**Application for Planning Permission for
Proposed House at Tuen Mun Town Lot No. 550 (TMTL 550), Tuen Mun, N.T.
(Application No. A/TM/601)**

Table 1: Responses to Comments from Government Departments on Planning Application No. A/TM/601 (13 November, 2025)

Revised Drainage Impact Assessment

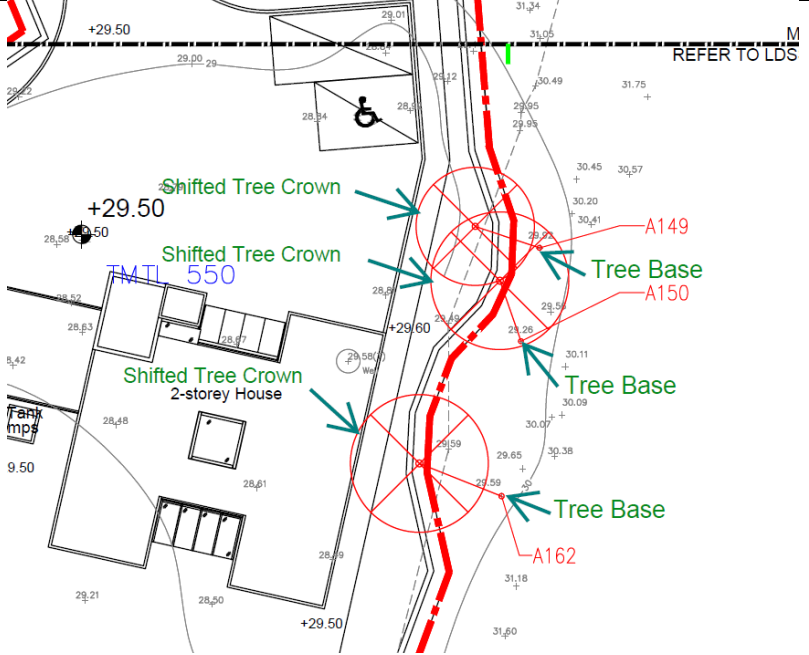
COMMENTS	RESPONSES
and drawing no. LDSS02A-TT02 ; and drawing no. LDSS02A-TT03. According to para. 2.7, it is noted that “...Refers to the recent topographical survey update of existing tree location, there is <u>no tree (base level) exactly located within the site...</u>” However, referring to drawing no. LDSS02A-TT01 and drawing no. LDSS02A-TT02, the base level of the existing trees (A136, A147, A149, A150 & A162) are located within the application site. The Applicant is advised to carefully review and verify the accuracy and consistency of the information provided.	show how far and where the crown shifted in tree survey plan to reflect the actual tree condition for reviewing potential tree impact. See below clarification. Please note Trees A147 and A136 will be affected by the roadworks, Trees A149, A150 and A162 will be affected by the boundary wall works. Regards of their poor leaning form or being as weedy tree, their main trunks and majority of their tree crown would be affected by the works, therefore they are recommended to be felled.

FIGURE 4

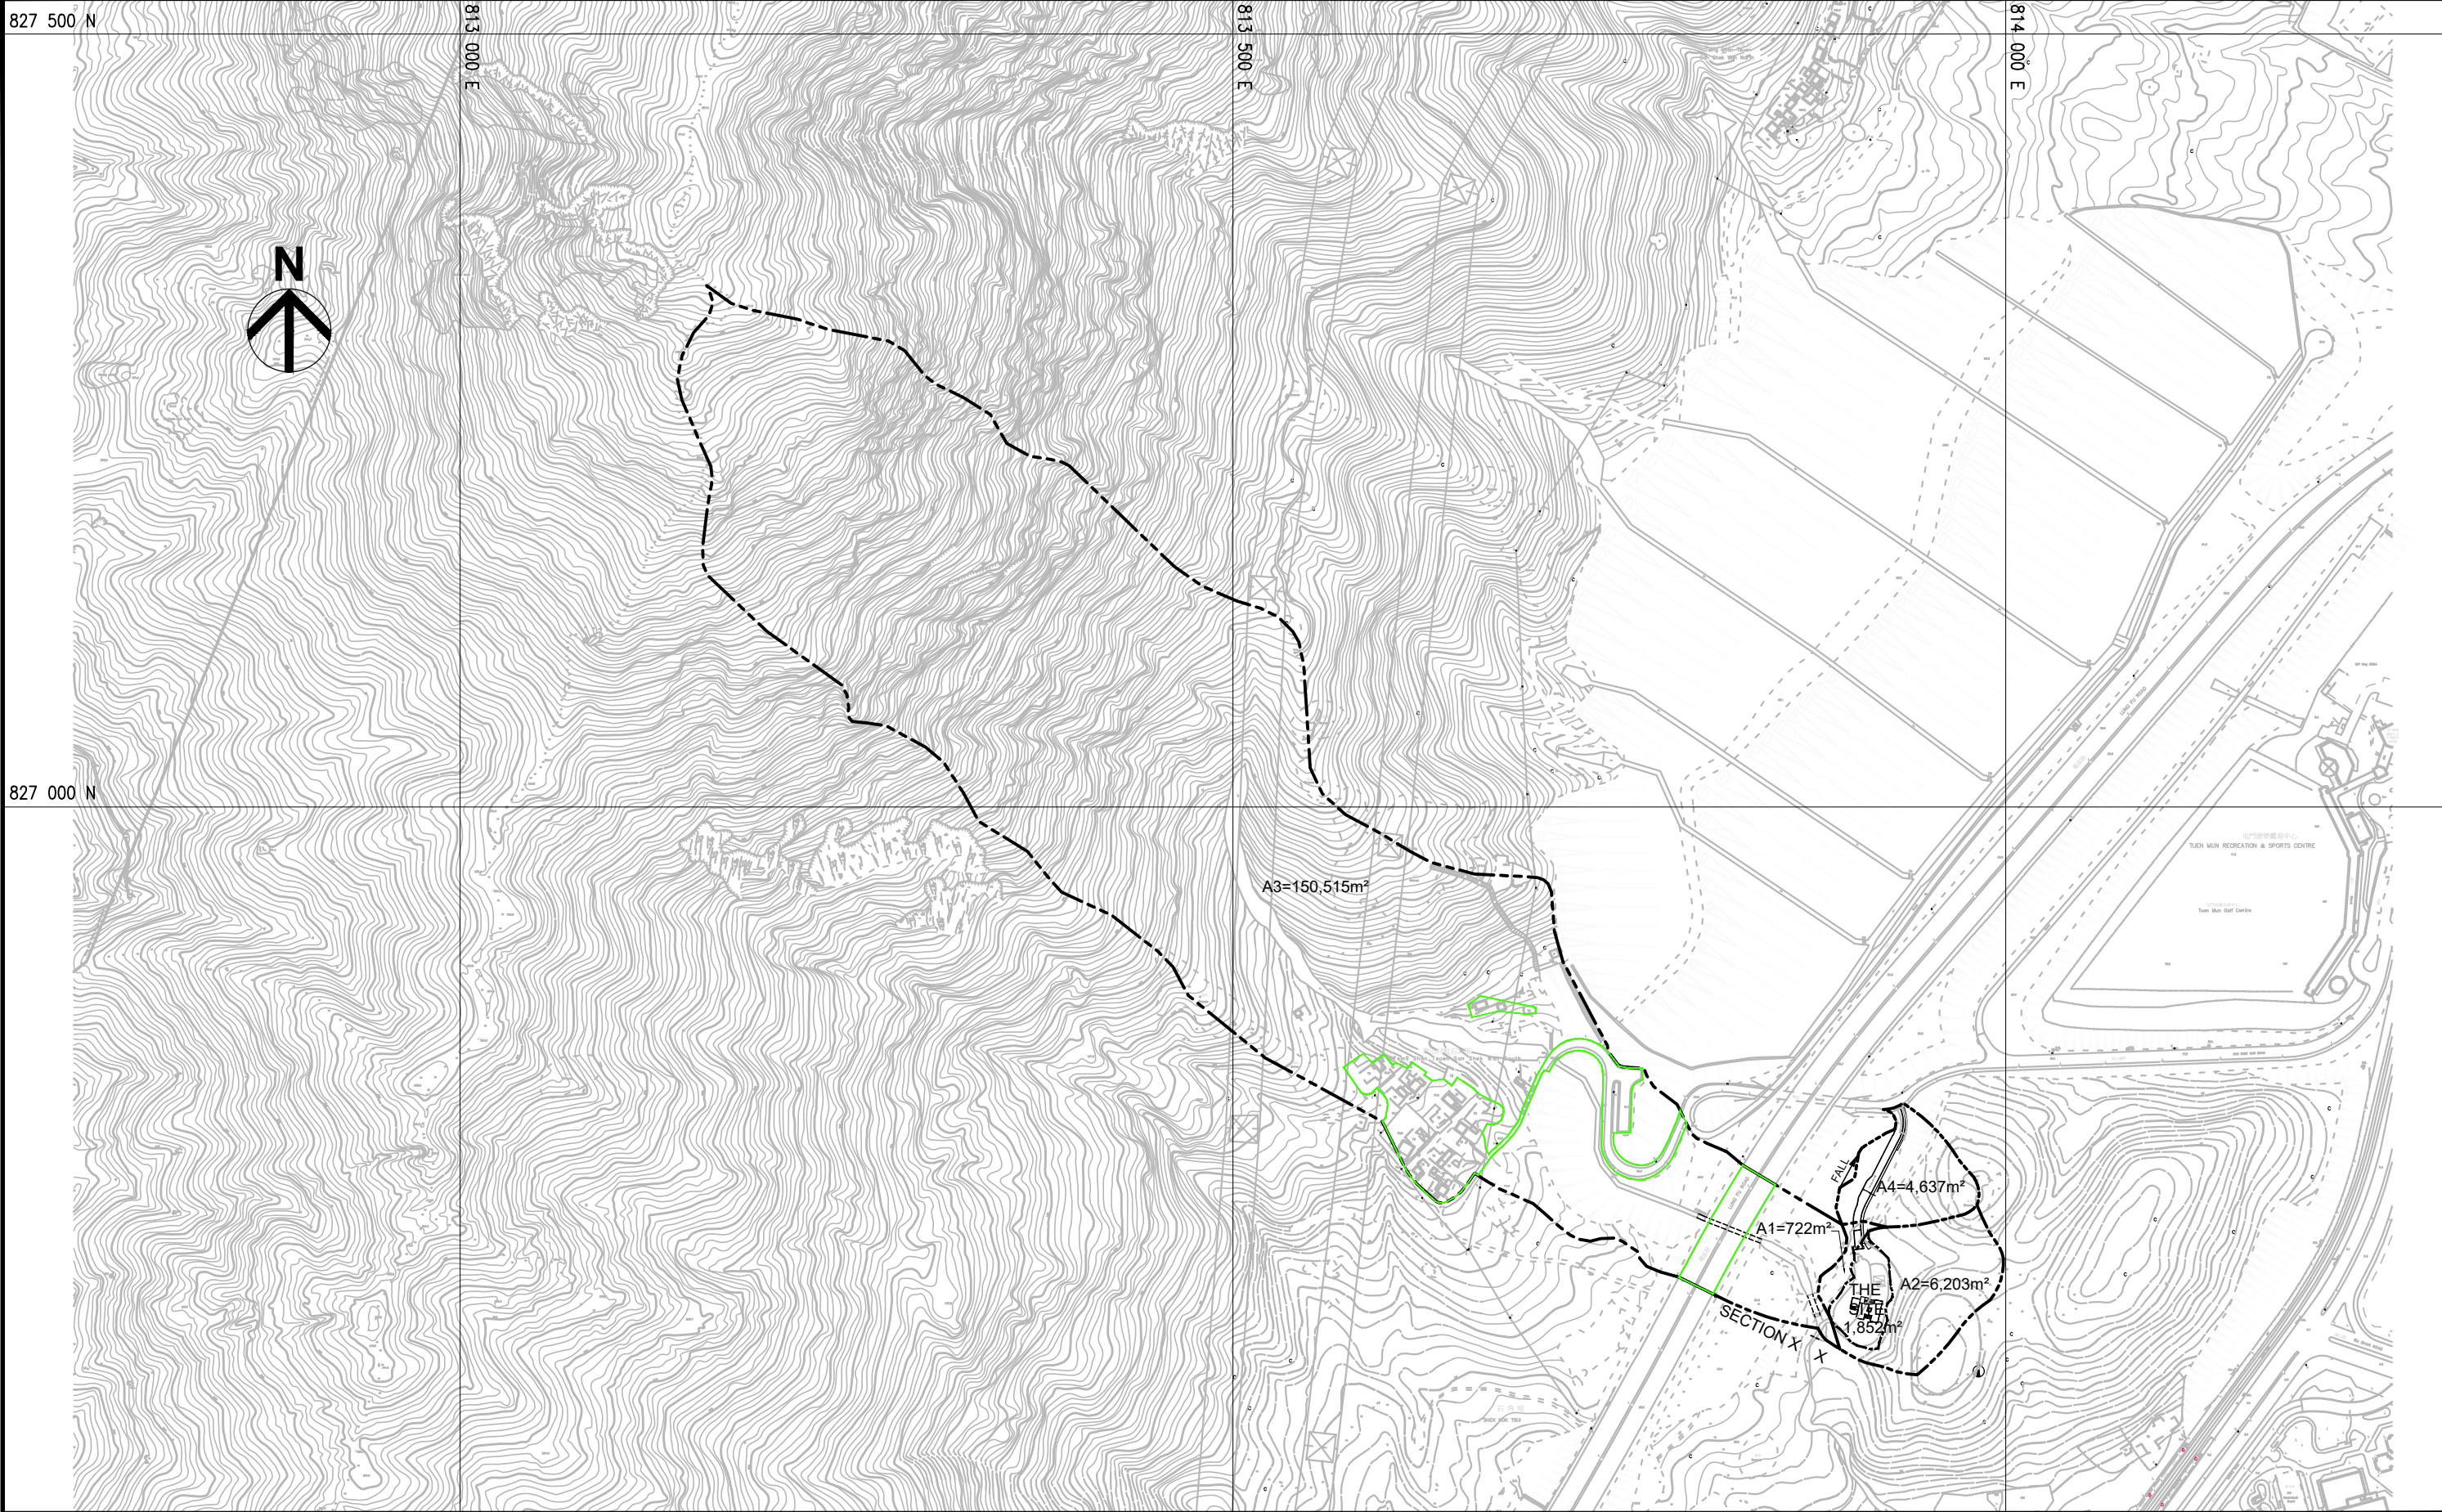
(b) Re: Figure 4, please show clearly the paved and unpaved area on this plan or on another plan with satellite imagery to confirm the correct adoption of the paving area assumption. In particular, it is noted that A3 is a large catchment where part of it appears to be paved area. In view of the above, please review whether it is appropriate to apply the unpaved catchment coefficient to the entire catchment and revise the calculations accordingly.	(b) Most of the area of the concerned subcatchment area, i.e. A3, is unpaved and some scattered houses exist near the uphill side of Shan Shek Wan Road. In order to cater for the existence of the currently paved areas, i.e. the scattered houses and the road, as demarcated in Figure 4, an equivalent catchment coefficient taking into consideration of the ratio between paved and unpaved areas of the concerned subcatchment area is therefore adopted in the calculations in the amended DIA.

PROJECT PROPOSED HOUSE DEVELOPMENT AT TUEN MUN TOWN LOT NO. 550 (TMTL 550), TUEN MUN, N.T.	何田顧問工程師有限公司 HO TIN & ASSOCIATES CONSULTING ENGINEERS LIMITED	
	TITLE PROPOSED STORMWATER DRAINAGE LAYOUT	SCALE 1 : 500 - A3	DRAWING No. FIGURE 5

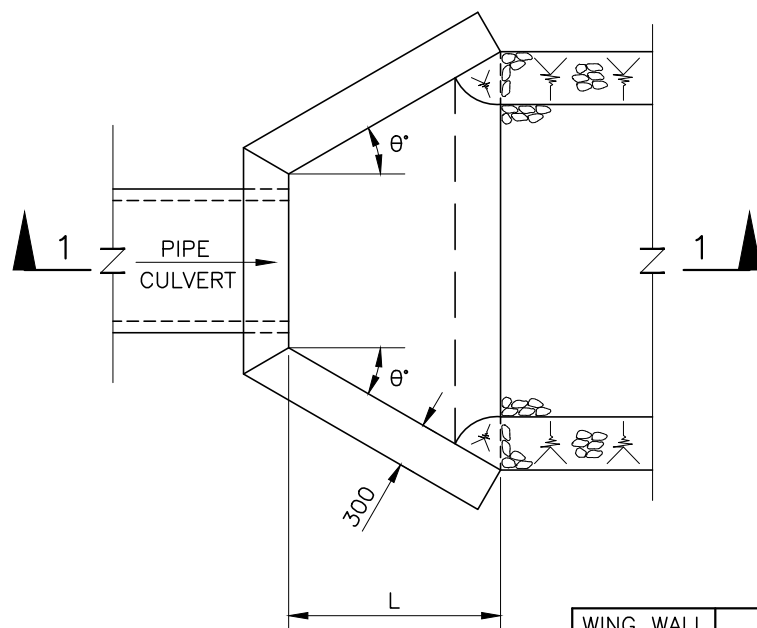
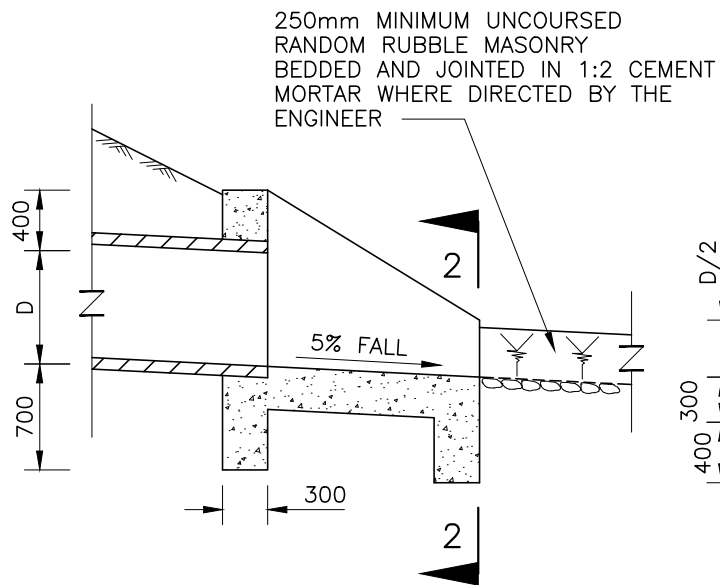
(c) Re: Figure 5, (i) Please also advise the fall of the catchment situated immediately west of the proposed road to demonstrate that runoff of such catchment would not be delivered by the proposed 300mm U-channel.	(c) (i) Contribution of the catchment situated immediately west of the proposed road to the proposed 300mm U-channel is reviewed according to the topographical results and is added into Figure 5 and the calculations.
(ii) The proposed terminal manhole TM should only have one outlet where its invert level is denoted as D.T.L. Please review if X1 is redundant.	(ii) The X1 is redundant and therefore deleted.
(iii) It is noted that the invert level of the proposed outfall (+28.33 mPD) is lower than the existing stream bed level (+28.41 mPD). The invert level of the proposed outfall should be higher than the existing stream bed level to maintain free discharge of the flow at the outfall and to avoid backwater effect.	(iii) The gradients of the internal channels are amended such that the invert level of the proposed outfall, i.e. +28.43 mPD, is not lower than the existing stream bed level (+28.41 mPD). Hence, backwater effect is avoided.

Section C-C

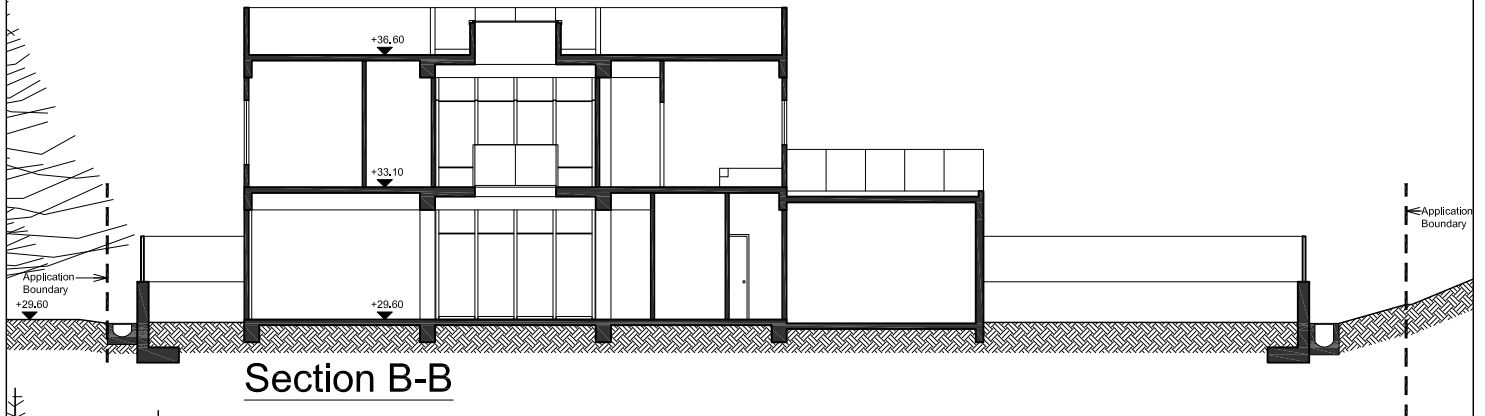
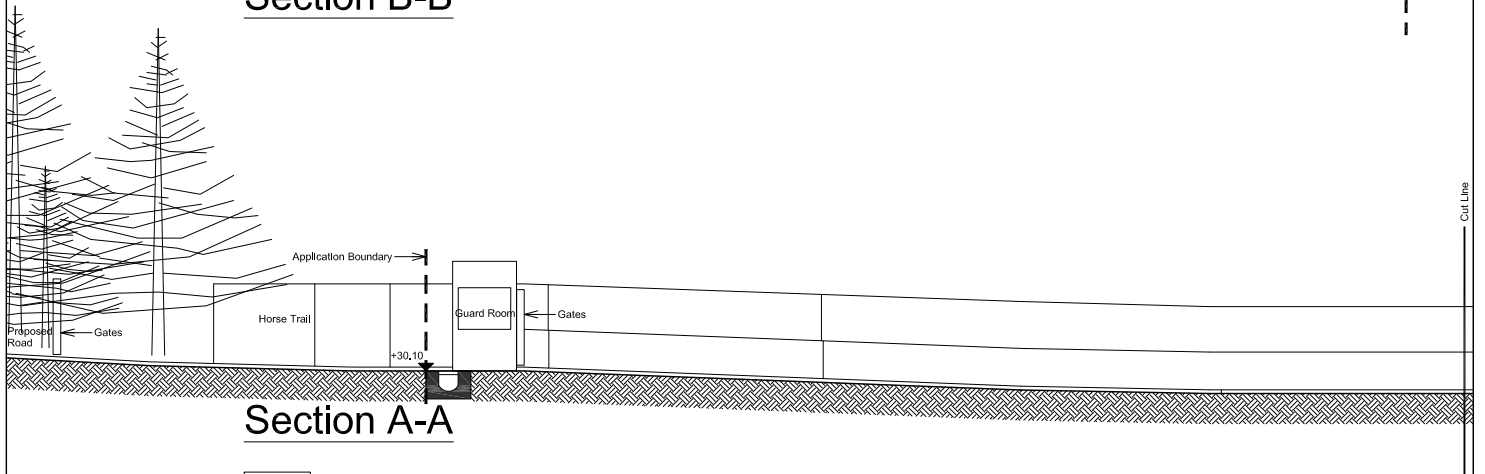
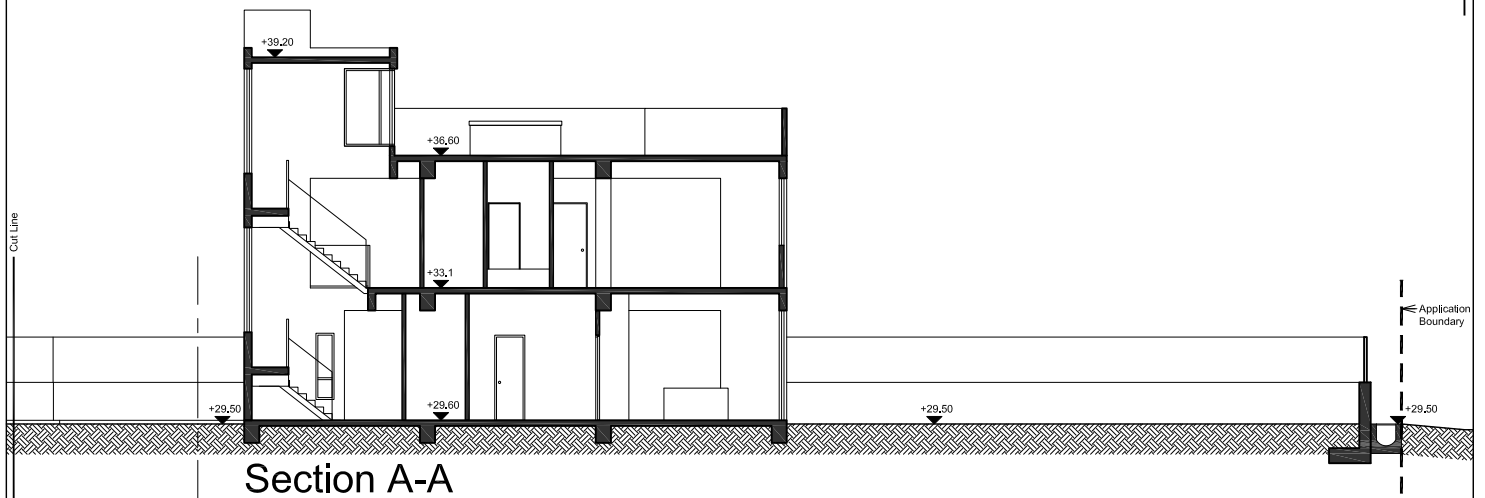
4. District Planning Officer/Tuen Mun and Yuen Long West, Planning Department (DPO/TM&YLW, PlanD)	
1. Planning Statement 1.1 Figure 7 - Section C-C in is apparently missing in the Master Layout Plan in Figure 4, please amend the figures accordingly.	1. Updated Figure 4 Master Layout Plan enclosed with building section C-C mark incorporated (see Annex D). Updated Figure 5 Floor Plan also enclosed with section A-and section C marks direction corrected (see Annex D).
